# 1 and 2 Murray Rose Avenue, Sydney Olympic Park Modification 1

Minor design changes to Site 2  
State Significant Development Modification Assessment  
(SSD 9403 MOD 1)

March 2022

**Figure 4 |** Proposed height changes (clouded in red) (Source: Applicant's site plan).

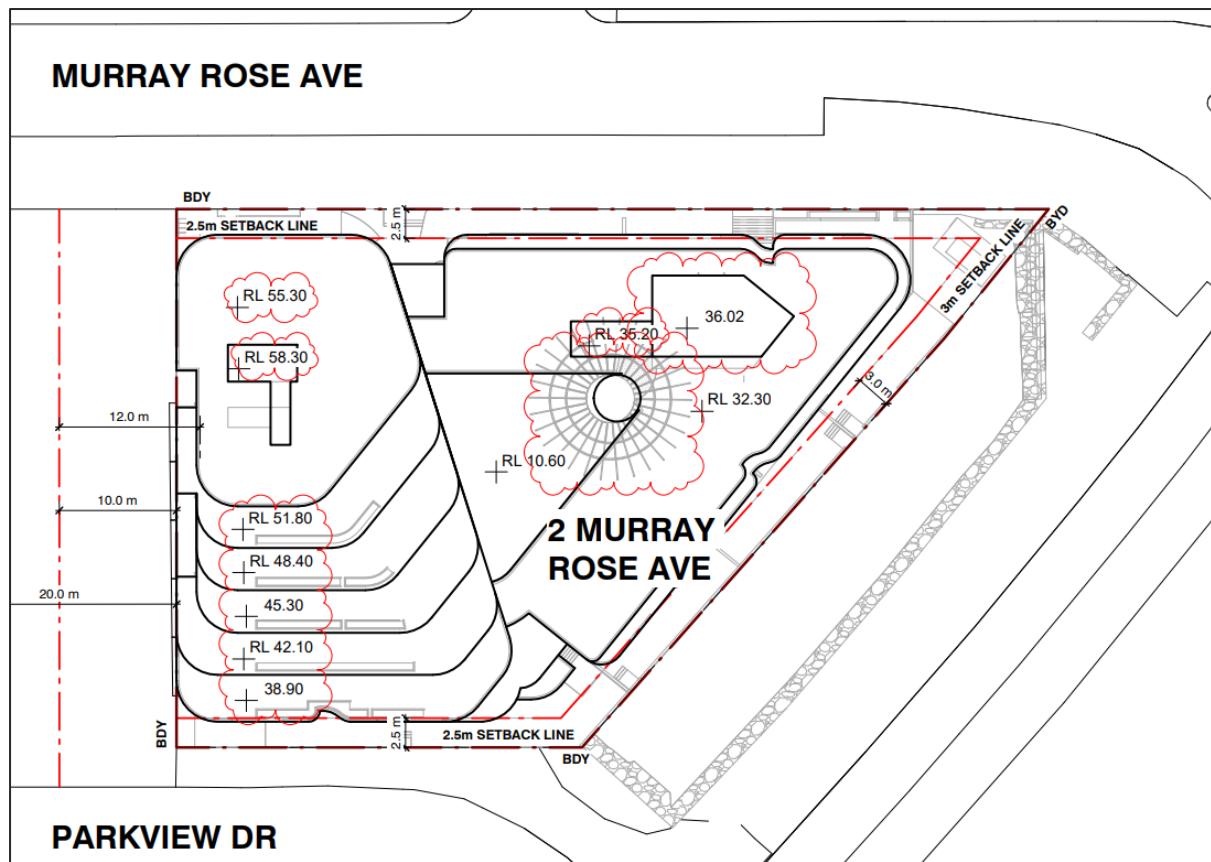
Aspect	Proposed changes
<b>Building height/floor levels</b>	<ul style="list-style-type: none"><li>• Increase in the building height by 0.7 m (from RL 57.6 to RL 58.3) (<b>Figure 4</b>) due to increases in concrete slab thickness between levels 1-9</li><li>• minor adjustment of finished floor levels between levels 1-9</li></ul>
<b>Building structure, façade and rooftop</b>	<ul style="list-style-type: none"><li>• Revised position of the mega columns between basement level 2 and level 9</li></ul>
<b>Residential dwelling mix</b>	<ul style="list-style-type: none"><li>• Conversion of a 1 and 3-bedroom apartment to a 4-bedroom apartment at level 13, resulting in an overall loss of 1 dwelling (126 to 125 dwellings)</li></ul>
<b>Basement</b>	<ul style="list-style-type: none"><li>• Minor amendments proposed to the four basement levels, including revised parking arrangements, fire egress, circulation, waste facilities as follows:</li></ul> <p><b><u>Basement Level 3:</u></b></p> <ul style="list-style-type: none"><li>○ modification to the layout of car parking spaces</li><li>○ realignment of courtyard lift</li><li>○ revised fire egress and core</li><li>○ updated storage</li><li>○ additional mirror</li><li>○ serviced amended</li><li>○ revised column location</li></ul> <p><b><u>Basement Level 2:</u></b></p> <ul style="list-style-type: none"><li>○ modification to the layout of car parking spaces including the removal of 2 standard spaces and the inclusion of an additional accessible space</li><li>○ provision of a rainwater pump and booster.</li><li>○ realignment of courtyard lift</li><li>○ amended services, core configuration, column location, mirror location, storage layout</li></ul> <p><b><u>Basement Level 1 (Figure 5):</u></b></p> <ul style="list-style-type: none"><li>○ modification to the layout of car parking spaces including the addition of 3 standard parking spaces and the removal of 2 accessible spaces</li><li>○ re-alignment of the wall to the fire/hydrant pump room</li></ul>

**Figure 5 |** Proposed Amendments – Basement Level 1 (Source: Applicant's plan).

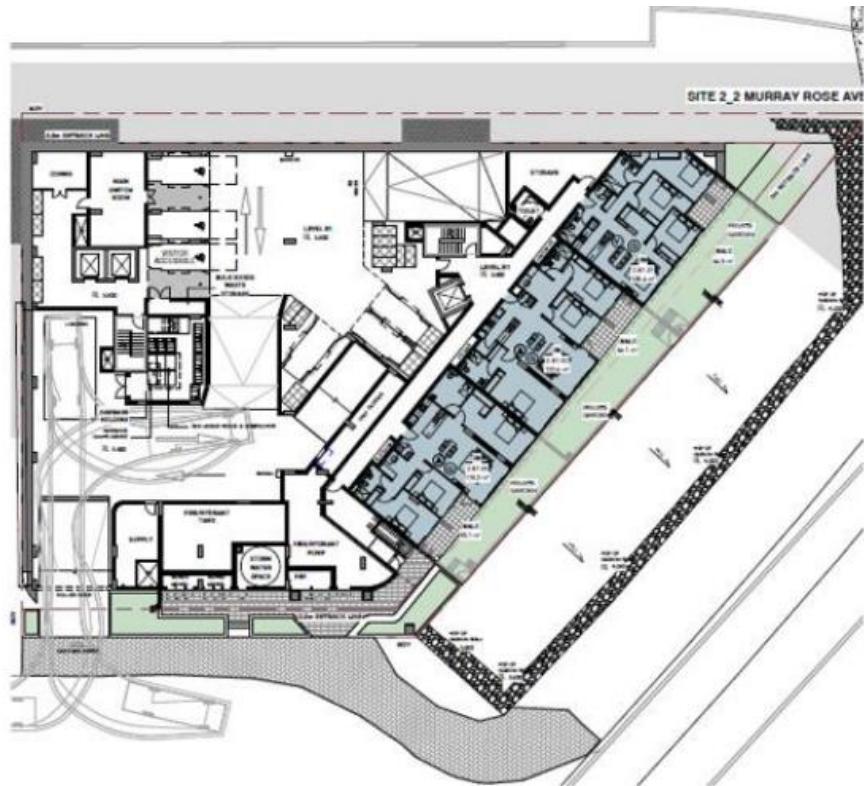
- modification to the layout of car parking spaces including the converting a standard space to an accessible space
- re-alignment of the wall to the fire/hydrant pump room
- modification to the layout of the garbage holding area
- minor relocation of the central core stair to the south
- relocation of the storage room and bathroom into the area formally occupied by the main switch room
- relocation of the main switch room into the area formally occupied by the storage space.

**Figure 6 | Landscaping amendments to level 1 – Central courtyard (Source: Applicant's plan)**

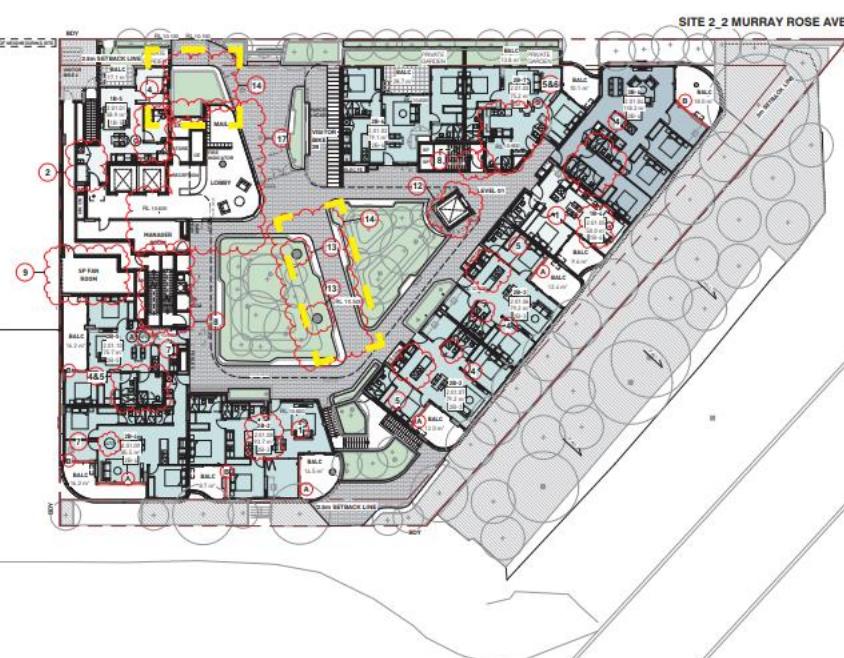
Minor amendments are also proposed to the level 1 central courtyard, including landscaping changes, installation of glass balustrades in place of perforated metal panels, reconfiguration of the central pathway and reduction in the gabion wall removal.

The Department notes that the revised landscaping design would improve the space and functionality of the level 1 and level 8 communal open spaces, whilst also providing for an additional communal facility (gym) for residents.

**Figure 8 |** Landscaping amendments to level 8 – roof terrace (Source: Applicant's plan)

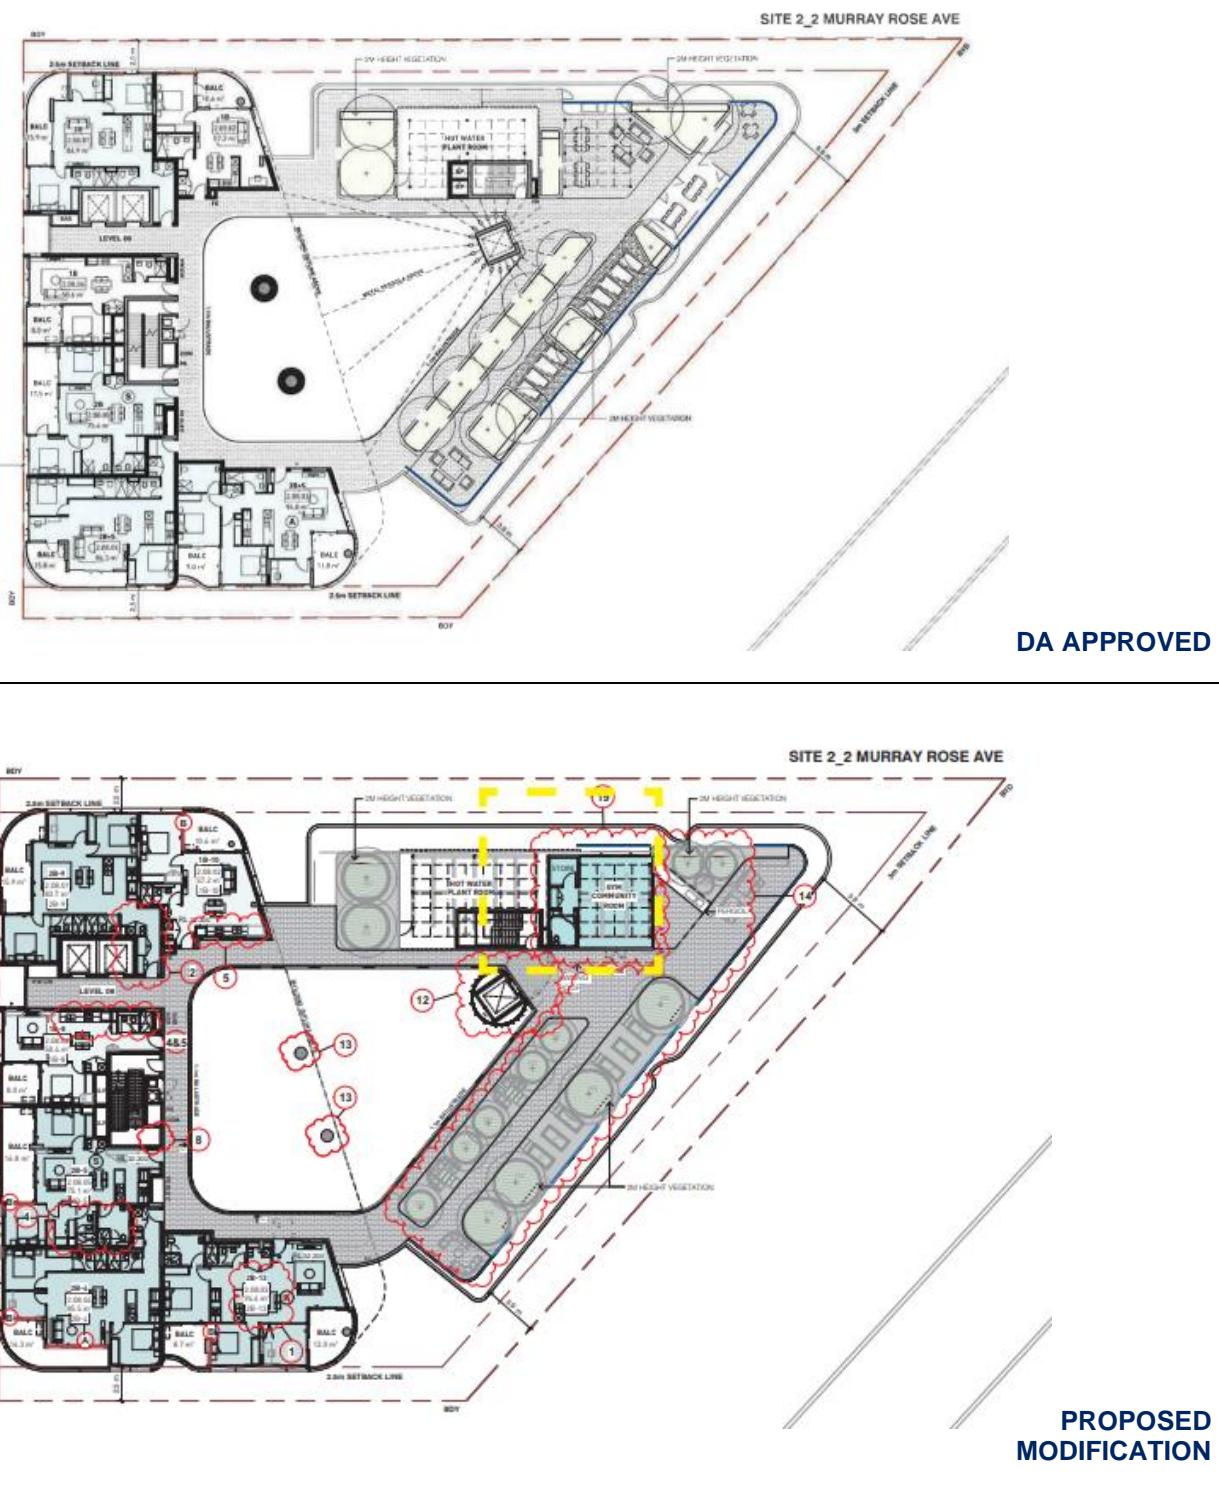
The modification application seeks to decrease the outdoor communal open space on the level 8 roof terrace by 51 m<sup>2</sup>, from 577m<sup>2</sup> to 526 m<sup>2</sup> due to the proposed new gym community room (**Figure 6**). Minor amendments to the rooftop landscaping layout are also proposed including an amended BBQ and seating area and revised roof planters modified to large GRC tubs.

The Department considers that the proposed changes to communal open space and facilities are acceptable as:

- the reduction to the total landscaped area is minor in nature
- the modification provides for an increased variety of community uses on site by providing a new gym for residents
- approximately 50% of the site area would still be provided for communal open space, exceeding the 25% minimal area recommended in the ADG.

**Figure 9 |** Approved northern elevation (top) and proposed northern elevation (below) showing the height changes and reposition of column structures (Source: Applicant's plan).

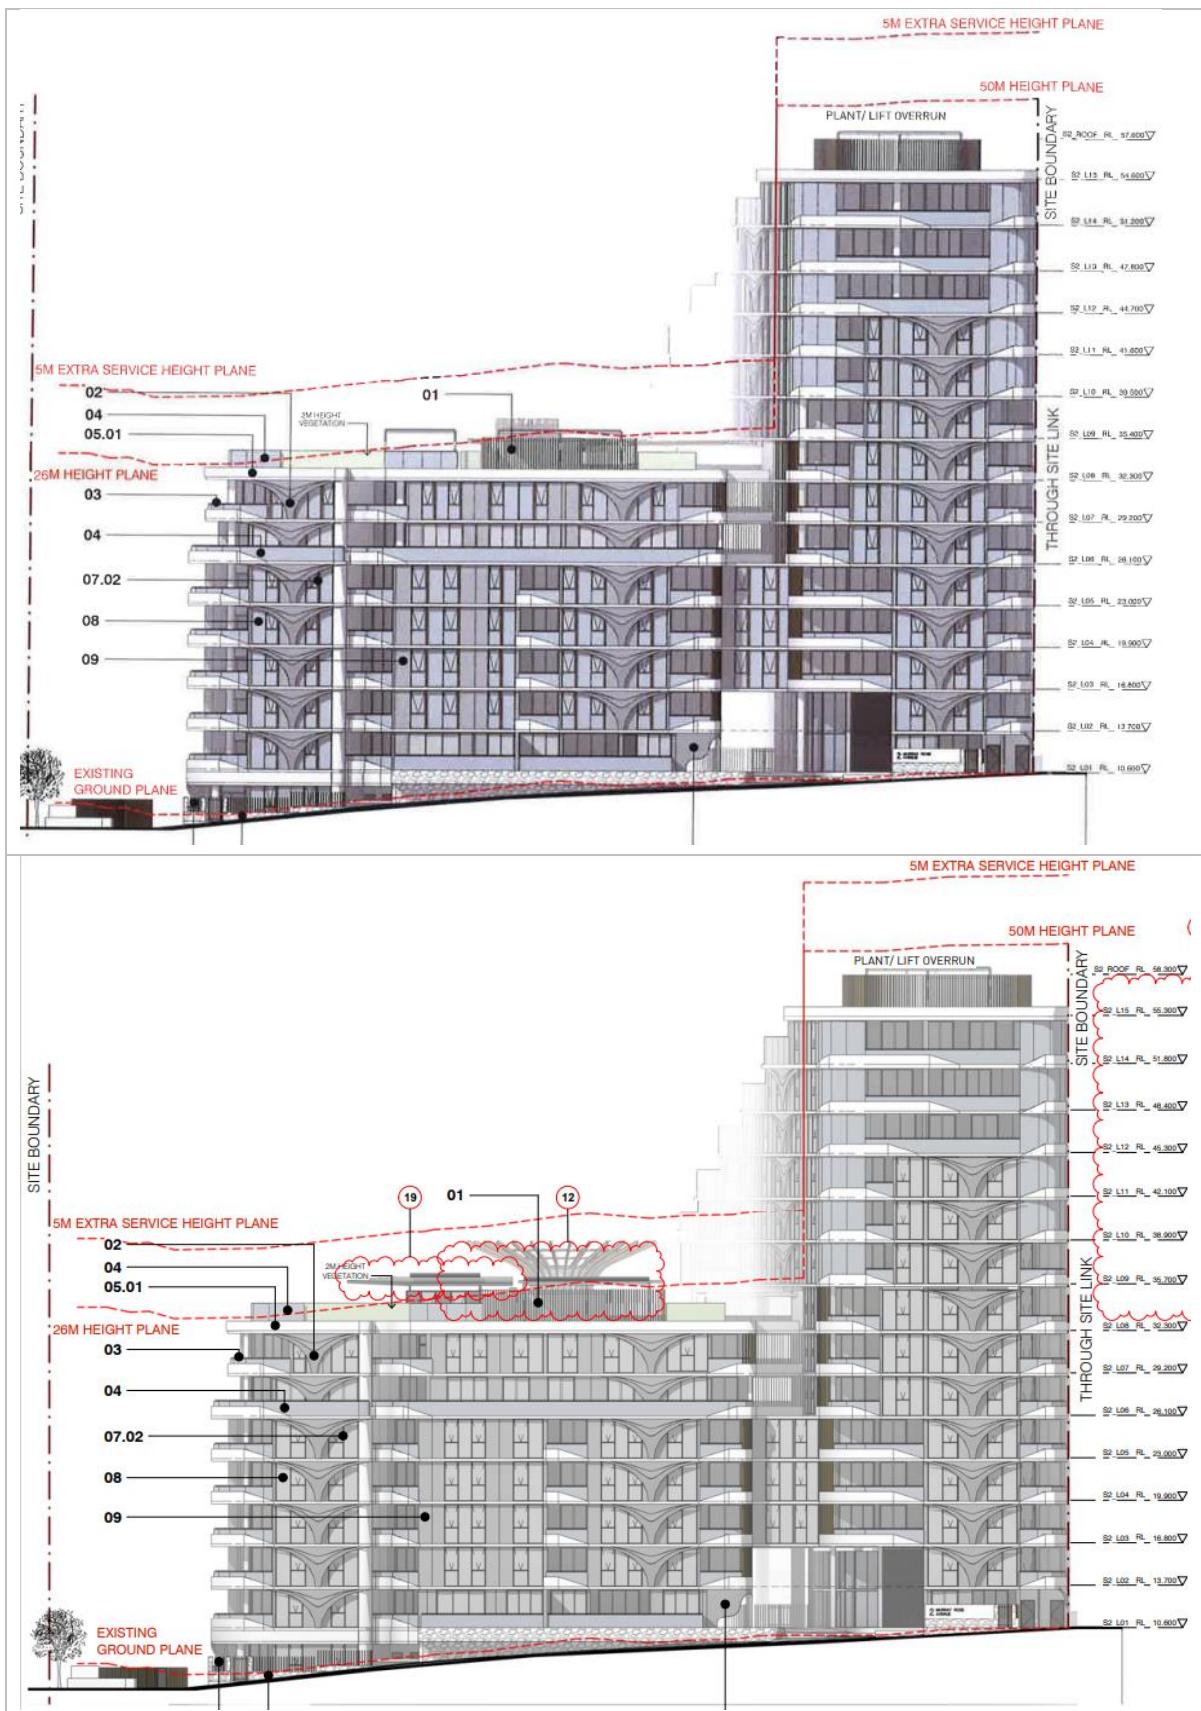
The modification seeks to increase the maximum height of building by 0.7 m from 57.6 m to 58.3 m, which exceeds the SSP SEPP controls (Figure 9).

The Department notes that the 0.7 m height increase is attributed to the thickening of concrete slab heights from the basement levels to level 9. As a result, the repositioning of the mega columns, which provides support from the basement levels up to level 9, is also required.

The Department considers the increase in height of the building is acceptable as:

- it is attributed to concrete slab thickening and would not significantly increase the bulk and scale of the building
- while it exceeds the SSP SEPP controls, it is minor in nature and the proposal would remain compliant with other relevant statutory provisions in EPIs
- it would maintain the architectural and urban design principles that were originally established as part of the Design Excellence Competition.
- it would be imperceivable from the surrounding area, streetscape and public domain and would not result in any adverse visual impacts
- it would result in negligible view loss impacts to adjacent and neighbouring properties
- it would not result in any additional GFA.

**Figure 10** | Shadowing diagrams for 21 June at 2pm (left) and 21 June at 3pm (right) (Source: Applicant's plan).

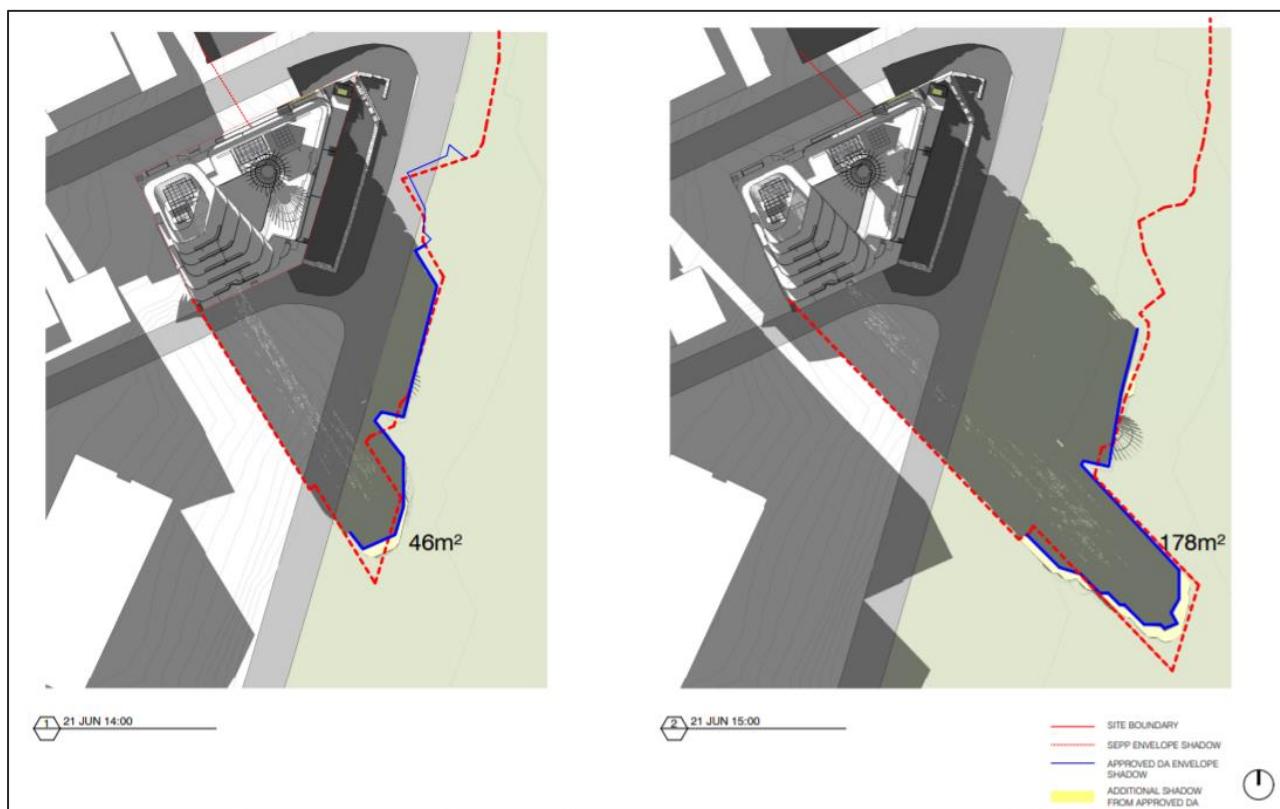
The Applicant contends that the additional overshadowing resulting from the 0.7 m increase in height is restricted to 2pm-3pm during mid-winter and is unlikely to result in any discernible additional impacts on the adjoining Badu Mangrove Wetlands as the overshadowing cast is minor in nature. Shadow diagrams illustrating the extent of additional overshadowing is provided in **Figure 10** below.

The Department notes that a substantial portion of the overshadowing caused by the proposed development will fall within the shadow created by the approved building envelope (**Figure 10**).

The Department also notes that the minor increase in height results in additional overshadowing during mid-winter (21 June) at 2pm and 3pm and the majority of this 46 m<sup>2</sup> increase (2pm) and 178 m<sup>2</sup> increase (3pm) sits within the SSP SEPP shadow envelope which is the shadow cast based on the maximum height limits for the site.

The Department therefore considers the additional overshadowing is acceptable as:

- it is minor in nature and the majority of shadowing sits within the SSP SEPP maximum building height envelope
- it would not overshadow any adjoining residential properties, and would continue to overshadow footpaths, roads and commercial properties to the south and south-west within
- it would not lead to any adverse environmental impacts to the Badu Mangrove Wetlands given that proposed overshadowing is marginal.

**Figure 11 |** Lobby amendments to Level 1 (Source: Applicant's plan)

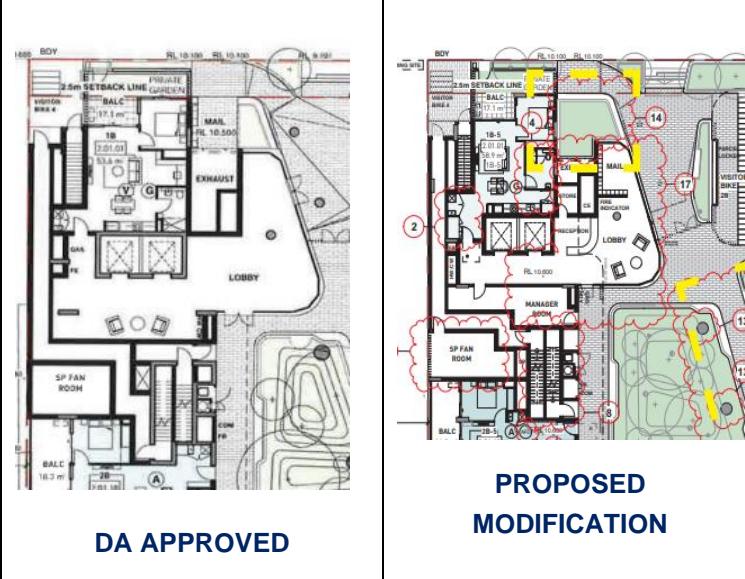
Issue	Findings	Recommendations
	<ul style="list-style-type: none"> <li>• 1 x 4 bedroom</li> </ul> <p>The proposal seeks approval to amalgamate 1 x 1 bedroom dwelling and 1 x 3 bedroom dwelling on level 13 to create a 1 x 4 bedroom dwelling.</p> <p>The Department notes the works proposed on level 13 are minor in nature and are wholly internal within the building.</p> <p>The Department supports the amalgamation of the two dwellings to create a 4 bedroom dwelling as the works are internal and would provide the development with an improved dwelling mix.</p>	the revised design drawings.
<b>Entry, vertical circulation and access</b>	<p>The Department notes the changes to the lobby space layout includes the provision of a manager room, mail area and lobby desk.</p> <p>The Applicant states the modifications proposed would improve the existing layout, functionality and accessibility of the lobby (<b>Figure 11</b>).</p> 	The Department recommends Condition A2 is updated to reflect the revised design drawings.

The Department supports the proposed amendments to level 1, level 15 and roof level as they would improve circulation and access noting changes to level 1 and roof level are internal and imperceivable from the public domain respectively.
